TEAM TIP

Communication #: T-23-12-01

Model Year(s): 2020-2024

SUBJECT: AUDIO SYSTEM UPDATES

IDENTIFYING 2-OHM AND 4-OHM SPEAKERS

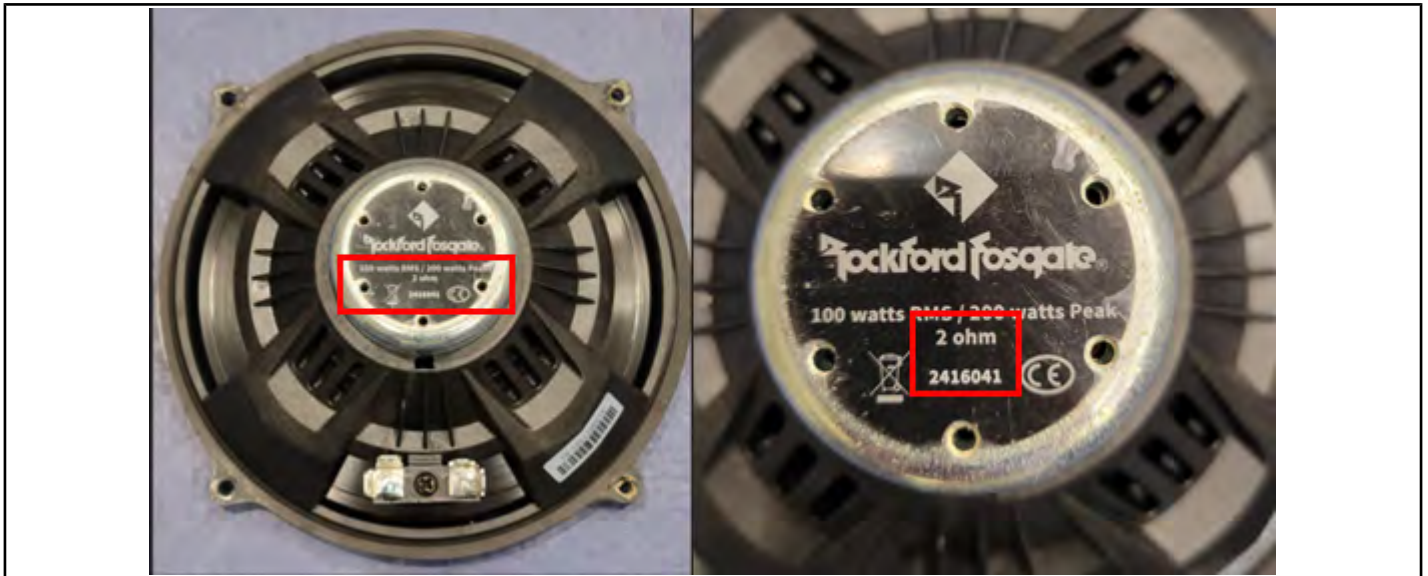
Each speaker is labeled with the resistance and part number as shown.

Do not mix 2-ohm and 4-ohm speakers. 2-ohm woofers and tweeters must be used together.

IDENTIFYING 2-OHM AND 4-OHM TWEETERS

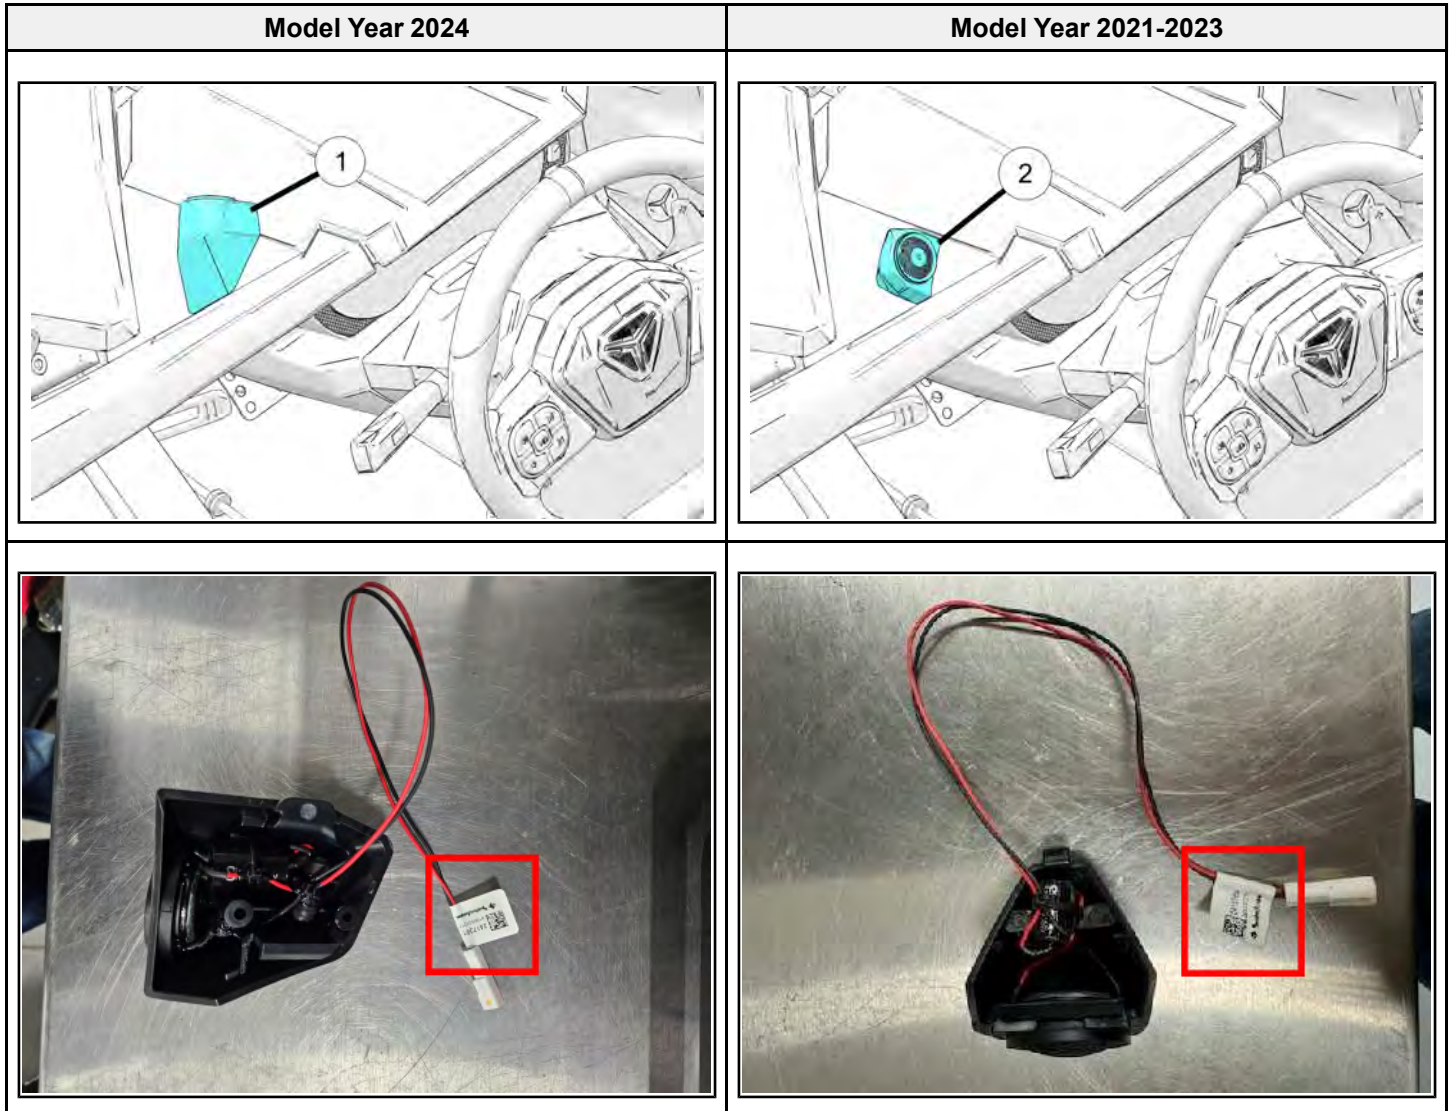
The Model Year 2024 tweeter ① features a new dash orientation compared to the Model Year 2021-2023 tweeter ②. Both tweeters have a tag which are labeled with the part numbers as shown.
